COUNCIL ASSESSMENT REPORT

Panel Reference	PPSSCC- 401		
DA Number	843/2022 PAN-261911		
LGA	City of Parramatta Council		
Proposed Development	Demolition of existing buildings, tree removal and construction of a 12 storey mixed use development consisting of a future 76 place centre based childcare centre with 87 residential units above 3 levels of basement parking. The proposal is a Nominated Integrated development pursuant to the Water Management Act 2000.		
Street Address	11-17 Shirley Street, CARLINGFORD NSW 2118		
Property Description	Address	Lot and DP	
	11 Shirley Street	Lot 10 DP 24777	
	13 Shirley Street	Lot 9 DP 24777	
	15 Shirley Street	Lot 8 DP 24777	
	17 Shirley Street	Lot 7 DP 24777	
Applicant Owner	D.R. Design (NSW) Pty Limited <ul style="list-style-type: none"> Nahra Properties Pty Limited Shirley Street Project Pty Limited Hi – Tech Construction Australia Pty Ltd 		
Date of Lodgement	27 October 2022		
Number of Submissions	3 unique submissions

Clause 4.6 Requests	Parramatta (Former The Hills) Local Environmental Plan 2012 <ul style="list-style-type: none"> Clause 4.1A – Minimum Lot Size for Residential Flat Building Clause 4.3 – Height of Buildings Clause 4.4 - Flo

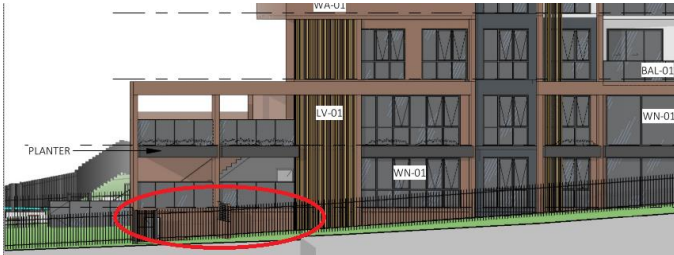
<p>C7 On sites with multiple buildings and/or entries, pedestrian entries and spaces associated with the childcare facility should be differentiated to improve legibility for visitors and children by changes in materials, plant species and colours.</p>	<p>Yes</p> <p>A separate entry is available for the childcare centre and the lobby for the residential units.</p>

<p>C8 Where development adjoins public parks, open space or bushland, the facility should provide an appealing streetscape frontage by adopting some of the following design solutions:</p> <ul style="list-style-type: none"> • clearly defined street access, pedestrian paths and building entries • low fences and planting which delineate communal/ private open space from adjoining public open space • minimal use of blank walls and high fences. 	<p>No</p> <p>The elevation plans submitted with the application indicates the provision of a front fence along the length of the street frontage. However, its dimensions have not been provided. Open style fencing is proposed along the southern boundary to address the open space corridor to the south. However, to ensure that the outdoor play area that cannot be screened by vegetation cannot be viewed from the open space corridor it is raised from the natural ground level. As a result, this portion of the development is a blank wall with a height that appears to be of a similar height to the boundary fence and is not an acceptable design outcome. See image below.</p>  <p>Figure 3: Southern elevation</p>

Figure 1: Excerpt, DA-0-900, Height Plane Building Diagram

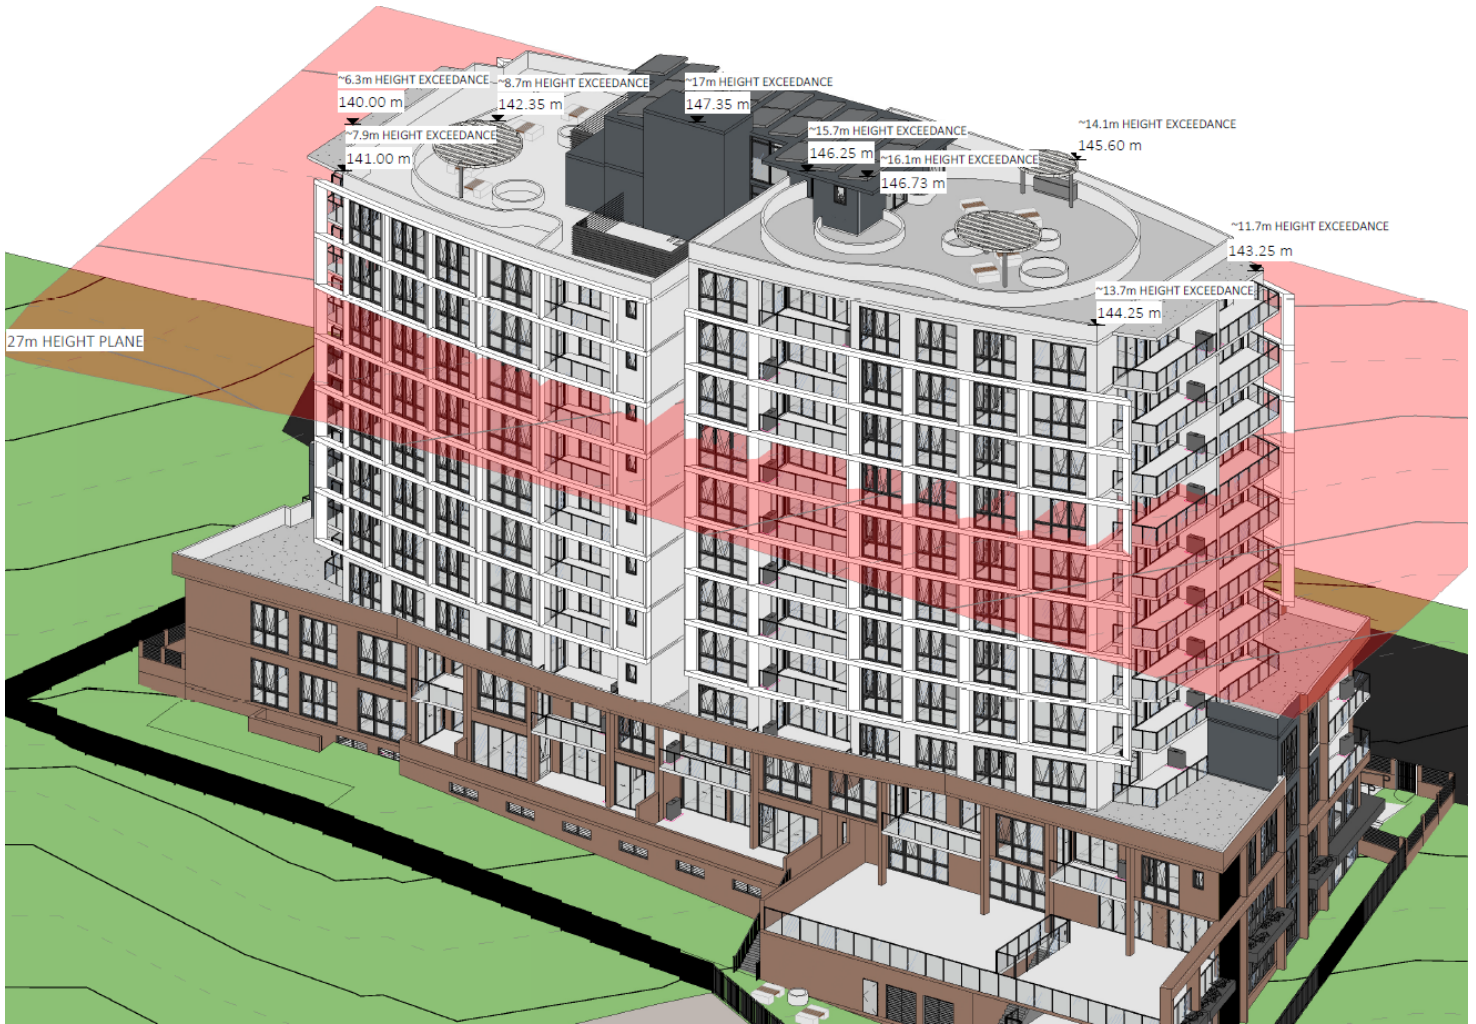
The height non-compliances are illustrated at DA-0-900 (See Figure 1 overleaf for excerpt of DA-0-900).

The maximum variation sought is 17m.

Clause 5.6(2) of the LEP permits an architectural roof feature to exceed the building height limit with development consent, subject to satisfaction of the matters in clause 5.6(3). The proposed development incorporates architectural roof feature elements associated with the roof garden. This includes pergolas, balustrades and planters. These elements are disregarded when taking into consideration the maximum height of the building. They do not represent the area of greatest height exceedance. They do not give rise to adverse impacts such as overshadowing and visual impacts.

Figure 9: Comparison Shadow 12 p.m. mid-winter Consented Development (left) and proposed development (right)

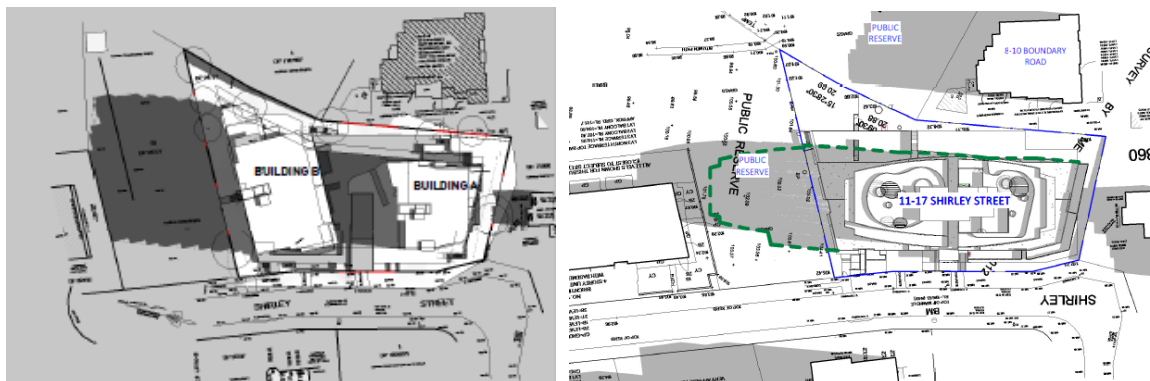
- Additional overshadowing to 1-9 Shirley Street does arise but the affected apartments but they maintain at least 2 hours direct solar access in midwinter consistent with SEPP 65 and the ADG.
- The proposed development does not overshadow apartments at 8-10 Boundary Road at mid-winter and therefore shadow impacts are considered minimal.
- The proposed development will impact the linear green open space to the south of the subject site. The overshadowing will be no greater than what currently arises from the consented DA on the subject site (DA/152/2017). While DA/152/2017 is lower than the proposed development the width of the tower to the southern boundary is larger and so the shadow is to the public open space is larger. A comparison of the 12 p.m. shadow between the consented development and the proposed development is provided in the Figure below.
